Project No.: 9437-2B	Date: May 8, 1995	Owner: Nassau County, Florida
Project Name: Fernandina International Tradeplex Roadway Contractor: Walding Company

CHANGE ORDER

Project No.: 9437-2B	Date: October 17, 1995	Owner: Nassau County, Florida
Project Name: Fernandina International Tradeplex Roadway Contractor: Walding Company

ATTACHMENT "A"

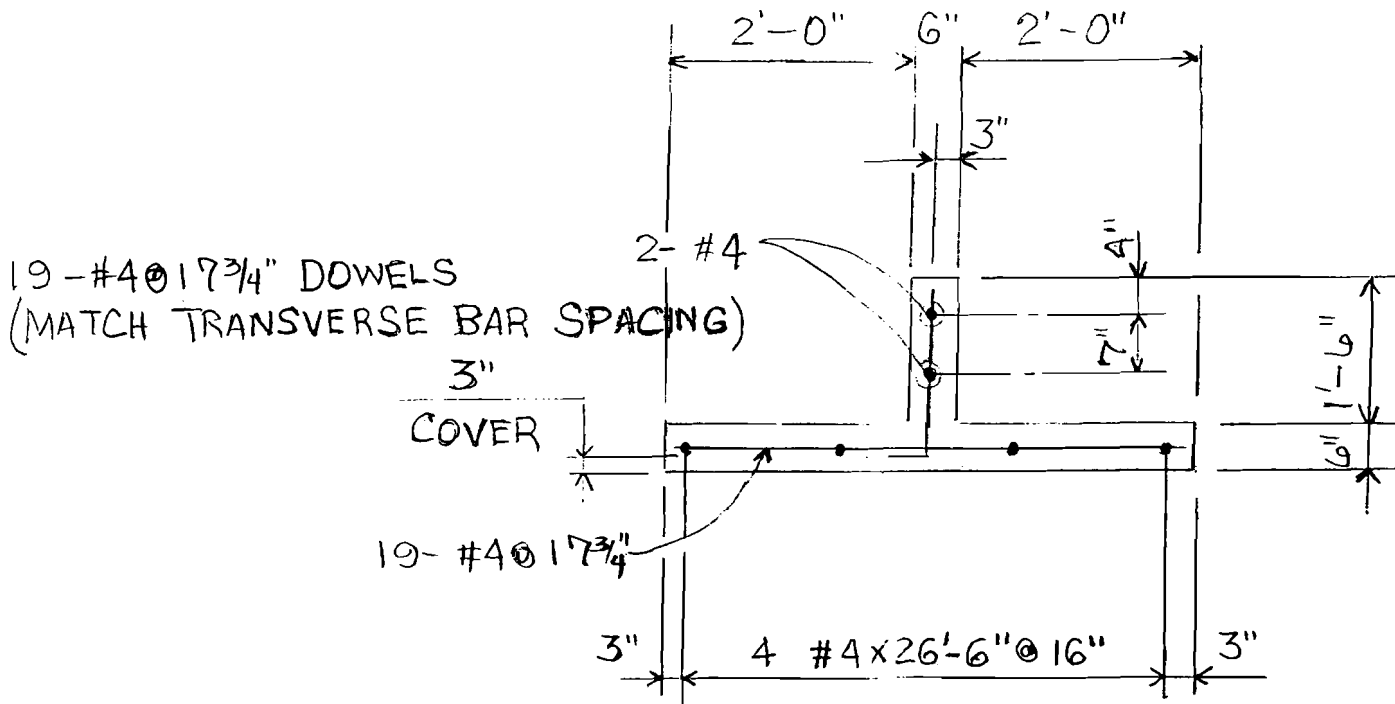
- (1) Sheet 11, Pond Bottom El. 15.00 is changed to El. 16.00.
- (2) Sheet 11, General Note 3 - "Upon completion of the spoil area Contractor shall seed and mulch all disturbed areas" is deleted in its entirety.
- (3) Sheet 36, Westside Ditch Block Details, Side View, Dimension of Width is changed to 4'-6", See Attachment "A".

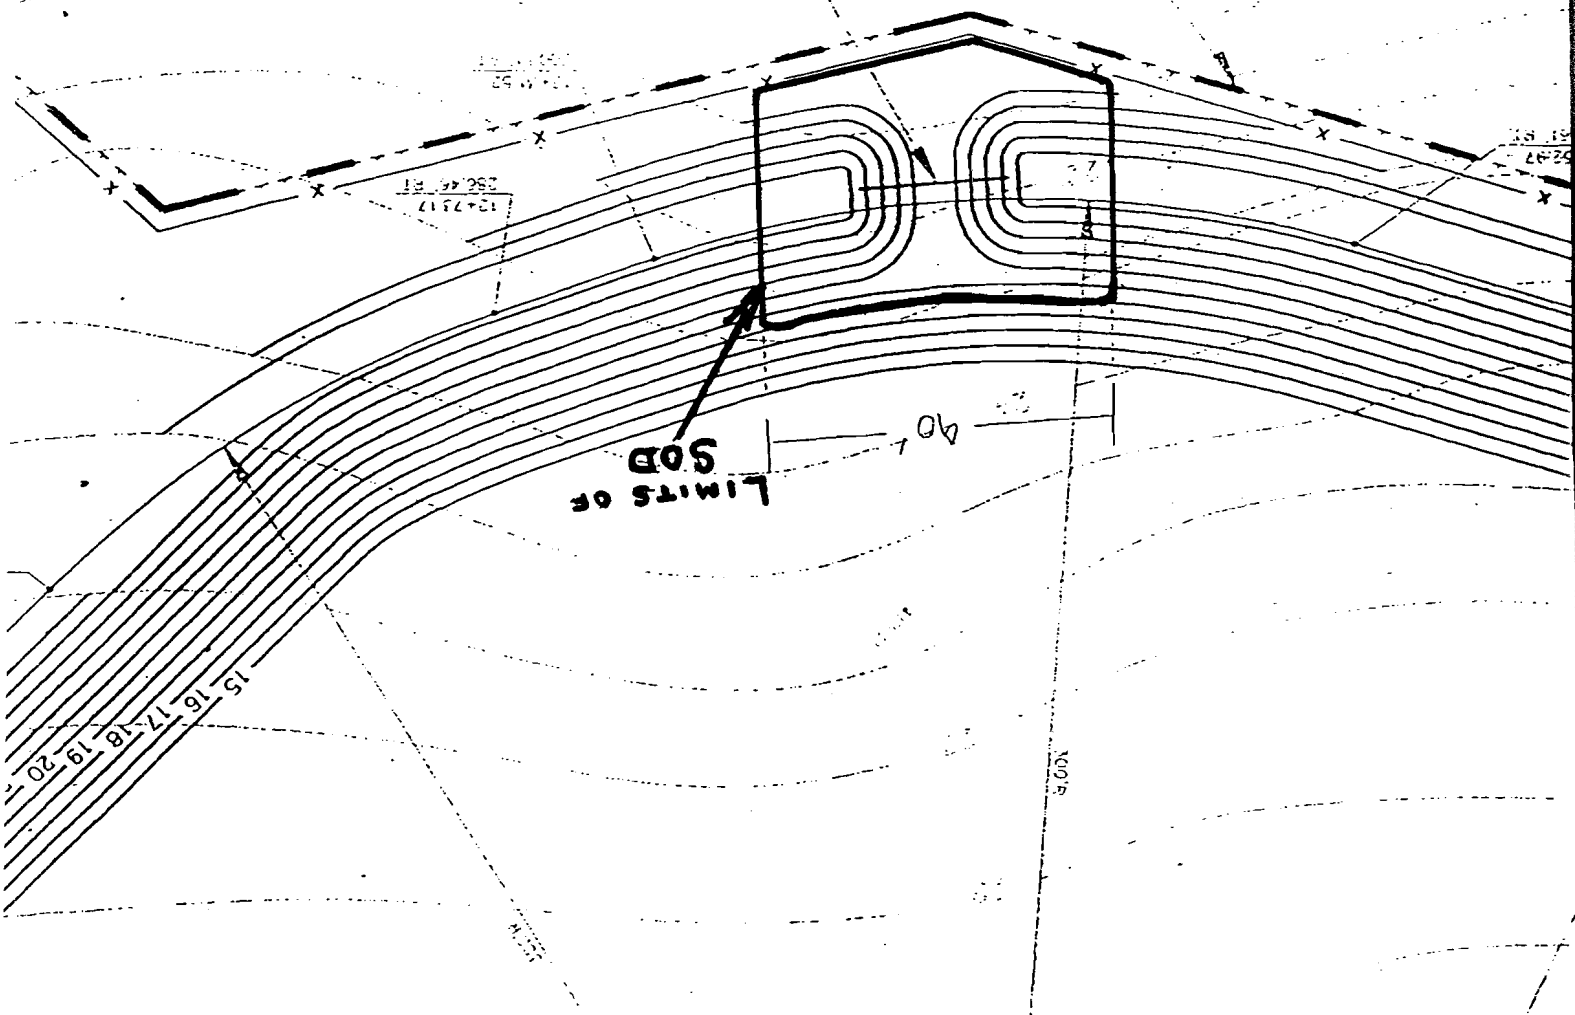
- f: Replacement of seed and mulch with sodding per sketches.
 - f.(1): Deletion of seed and mulch replaced with sodding per sketches.
- (10)
 - a. Sod from shoulder to bottom of ditch per sketch.

VER. 1" = 4'
 Item 10 C.

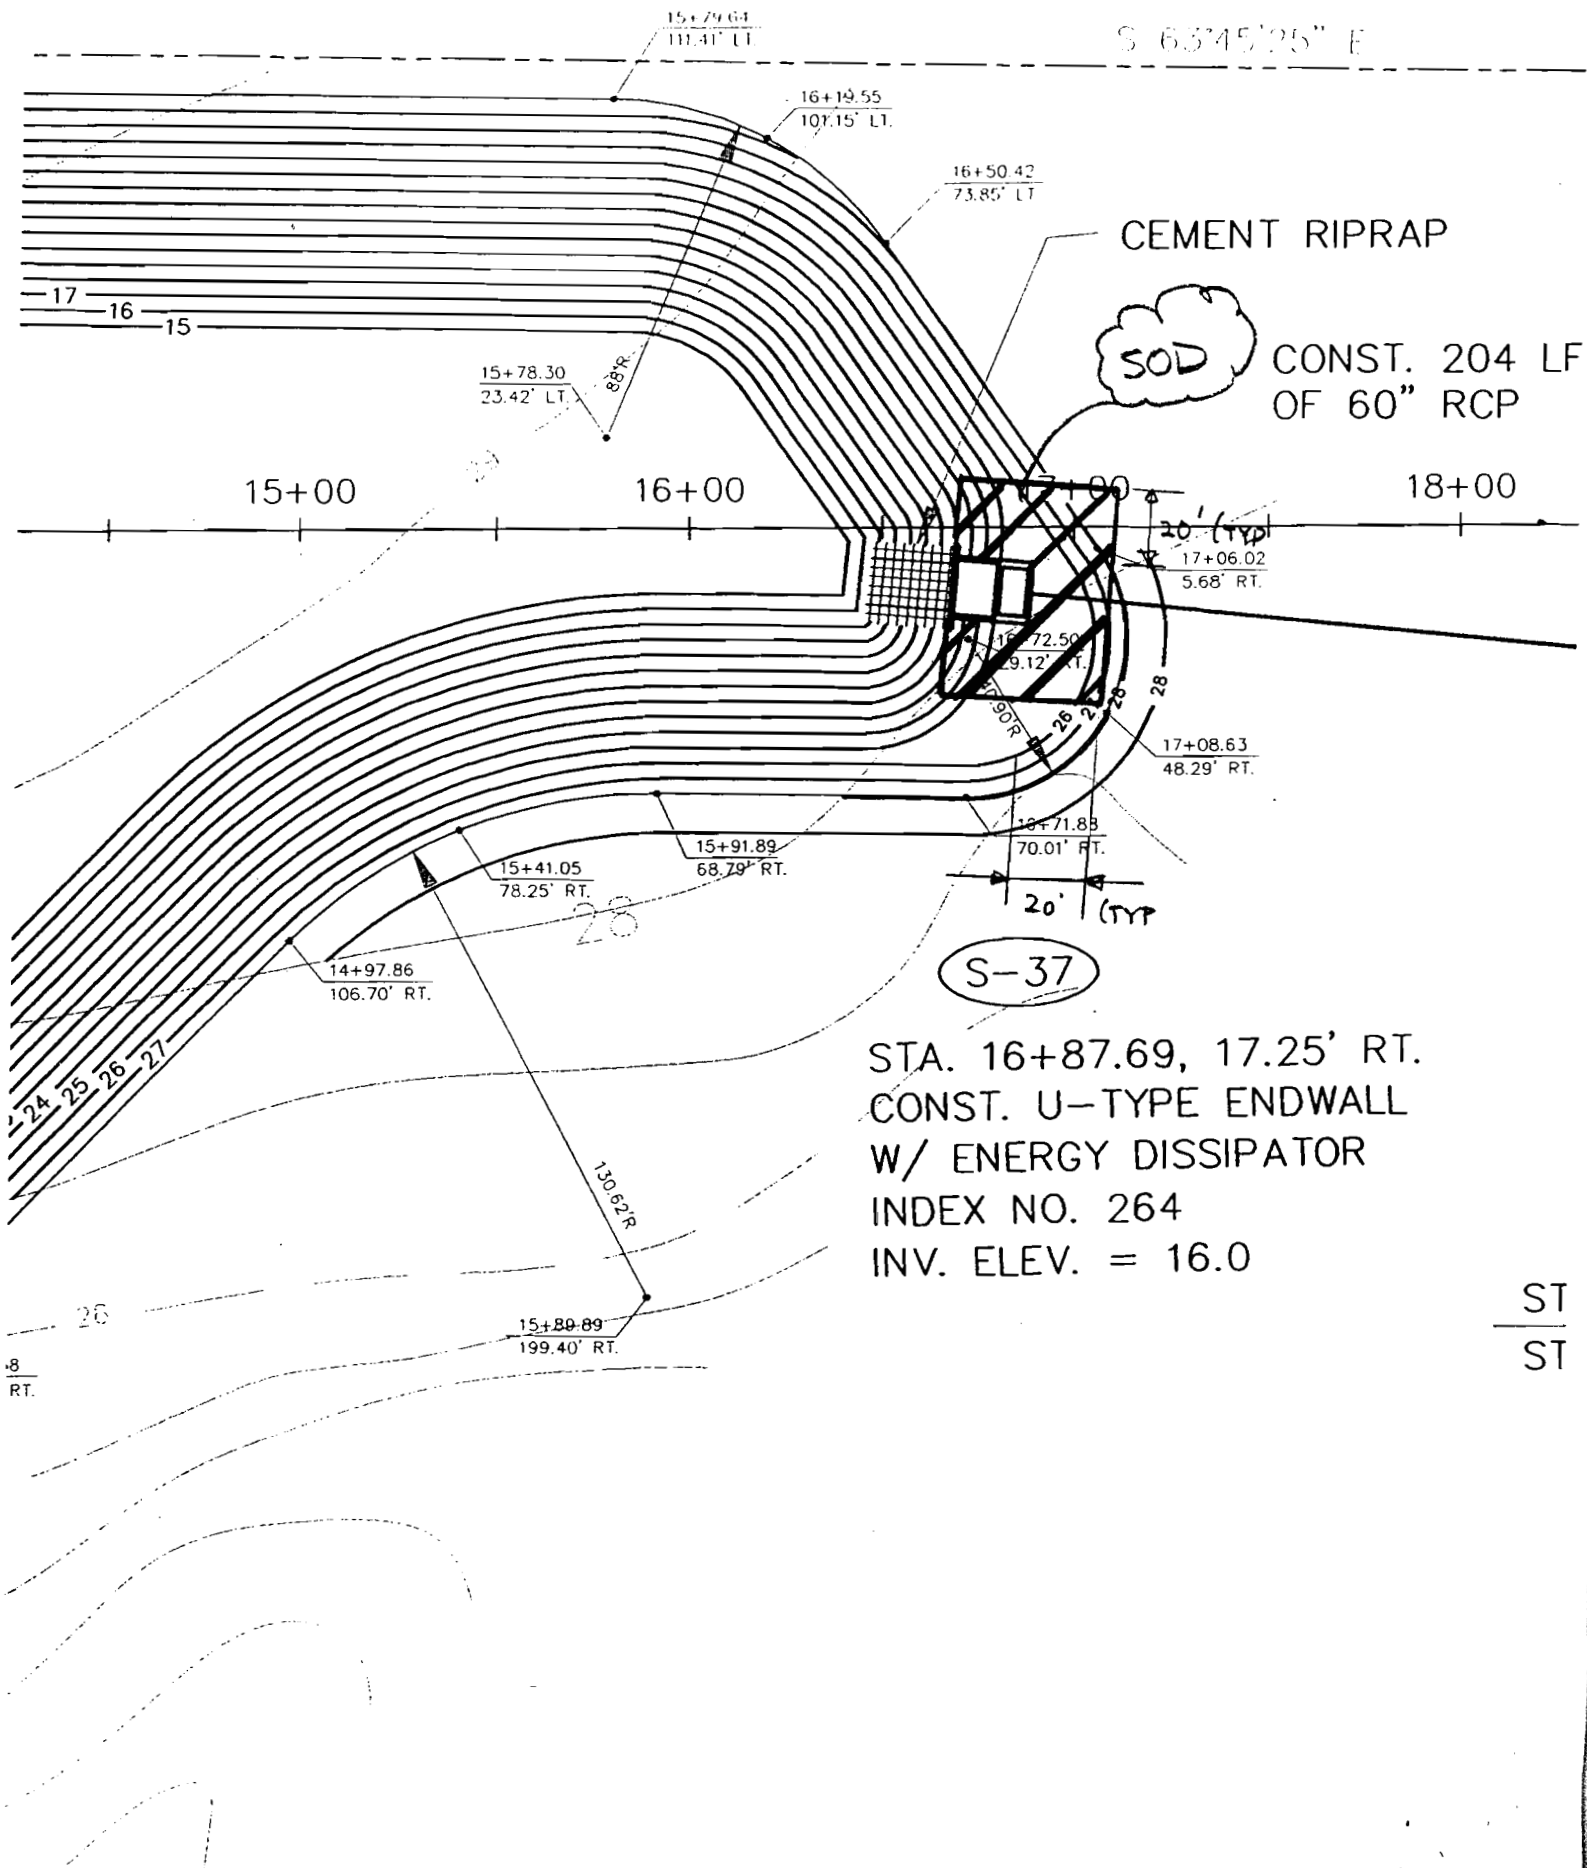
- b. Additional sod around structure S-37 per sketch.
 - c. Concrete pad at secondary access road (2 locations).

CONCRETE PAD DETAIL (U.T.S.)

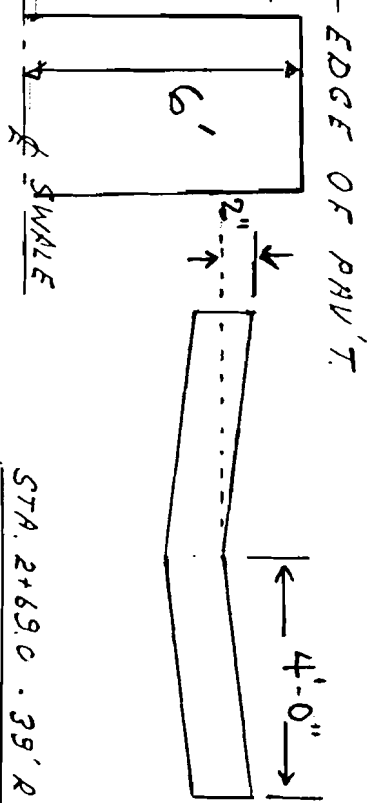
PLACE 8' WIDE CONCRETE
 PAD X 4" THICK FROM
 EDGE OF PAVEMENT

Item No 10 d.

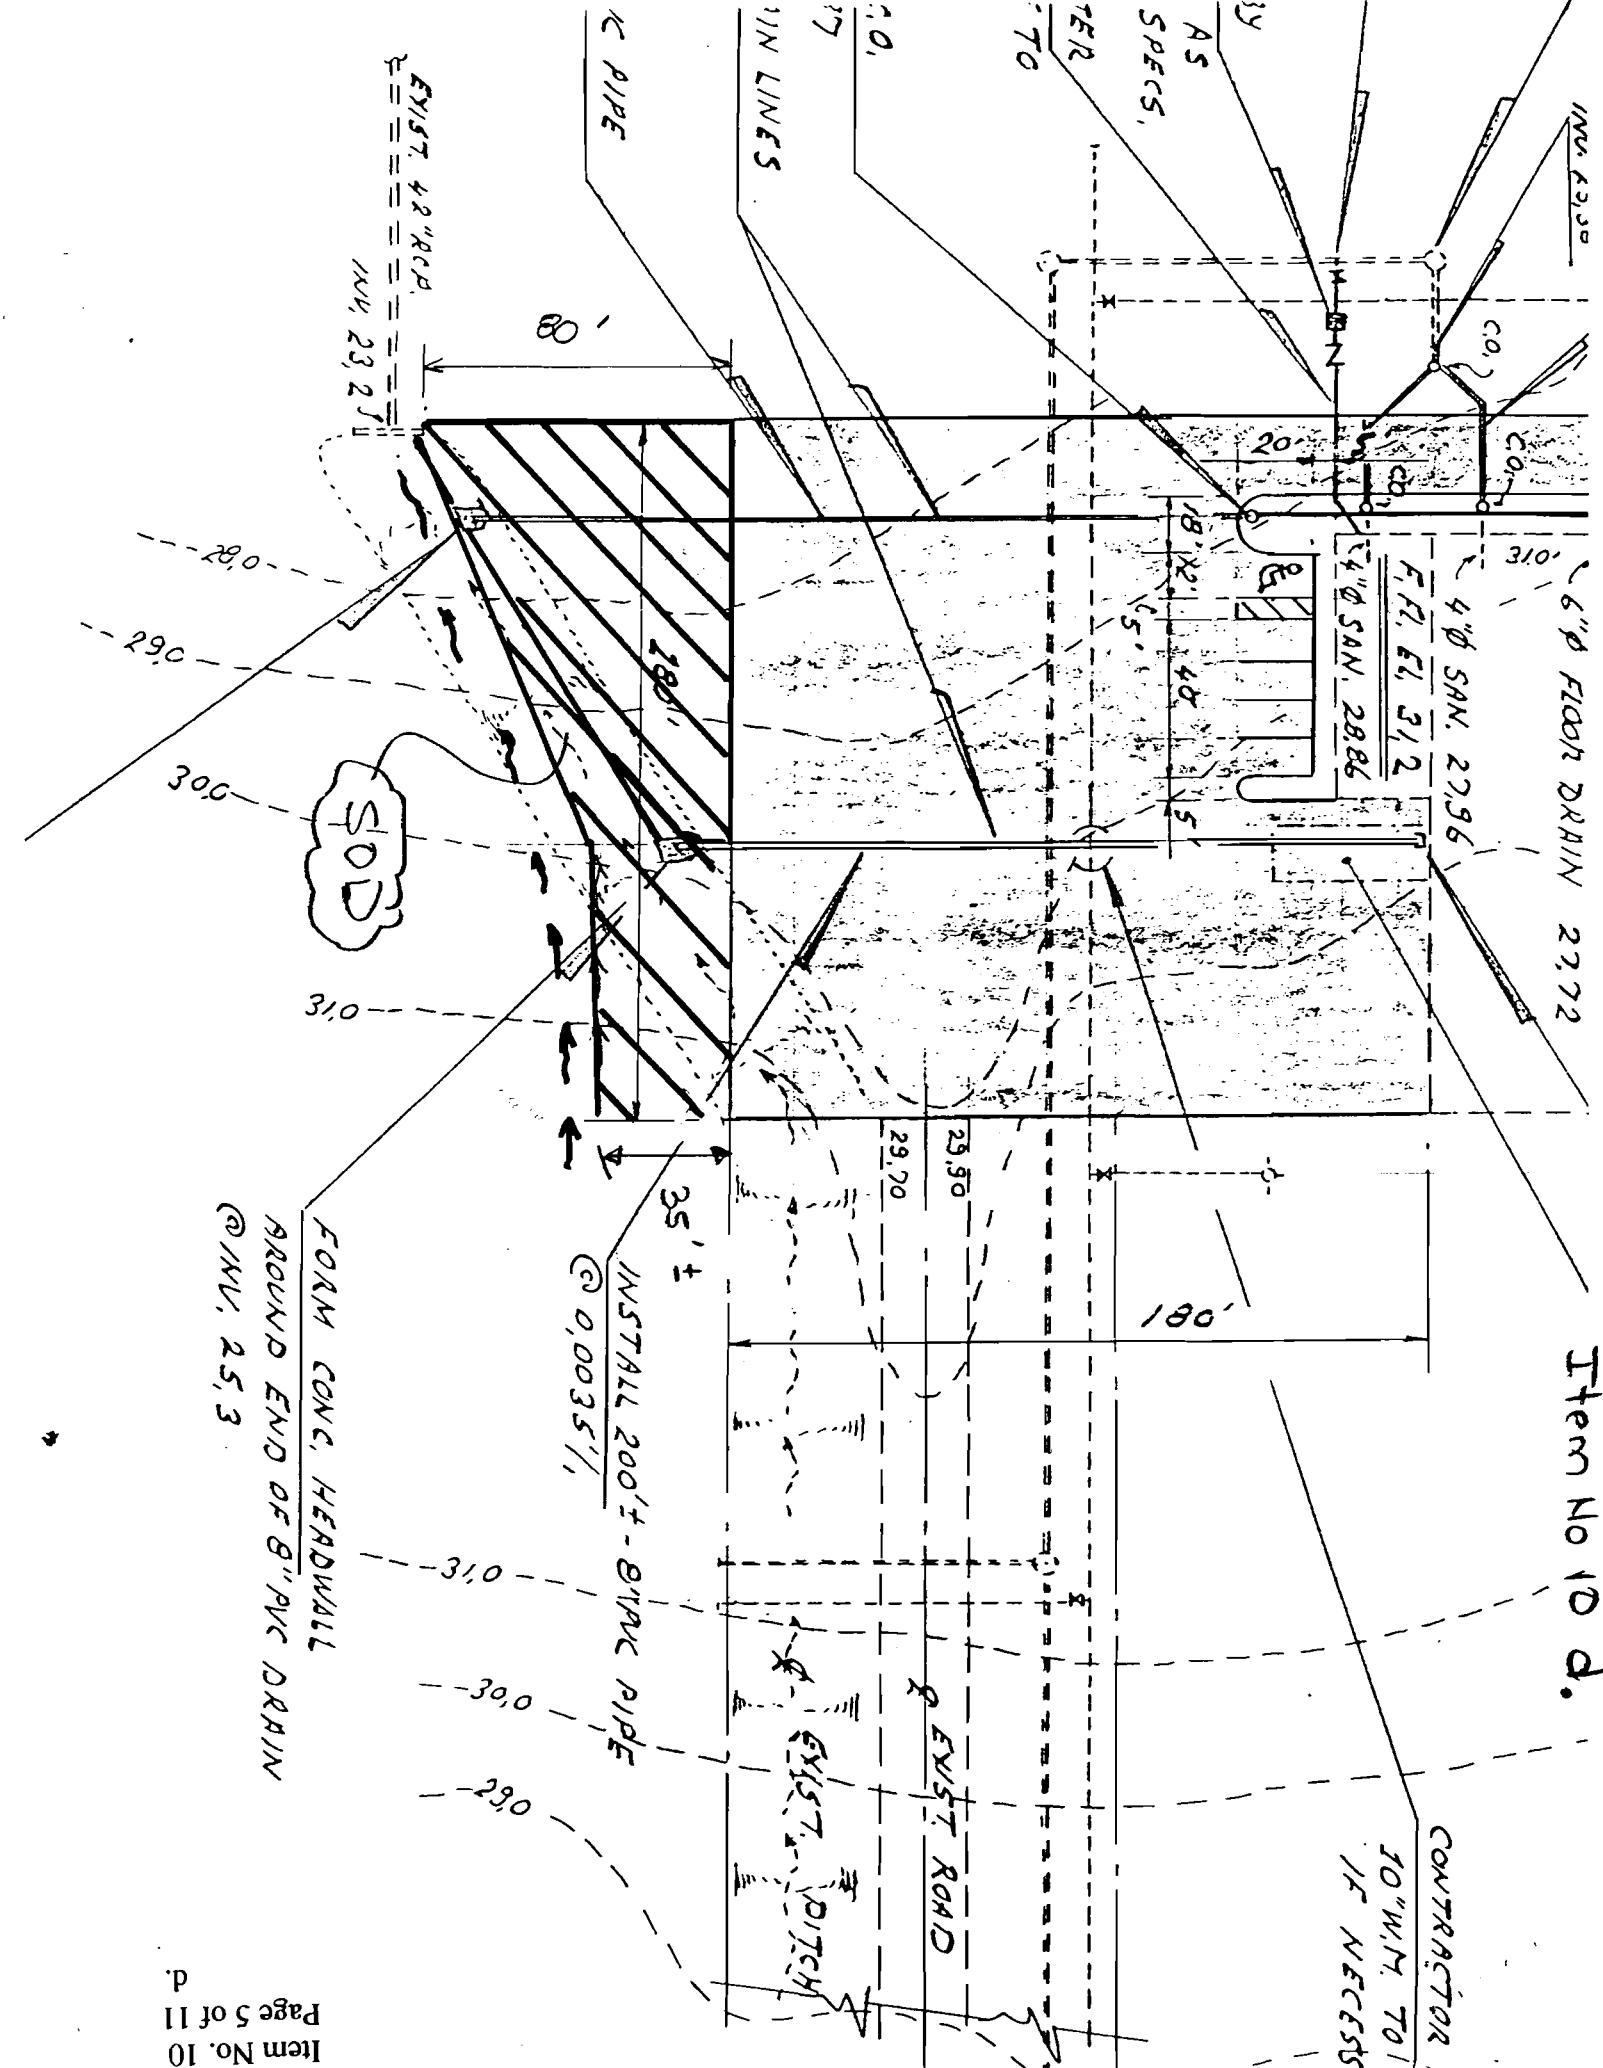
- d. Sod at headwall of 42" pipe per sketch.
- e. 4" thick concrete pavement and 4" thick concrete ditch pavement per sketch.
- f. Sod median area per sketch.
- g. Sod front area per sketch.
- h. Additional rubble riprap at weir per sketch.
- i. Sodding at cross culvert per sketch.
- j. Add concrete between headwalls per sketch.
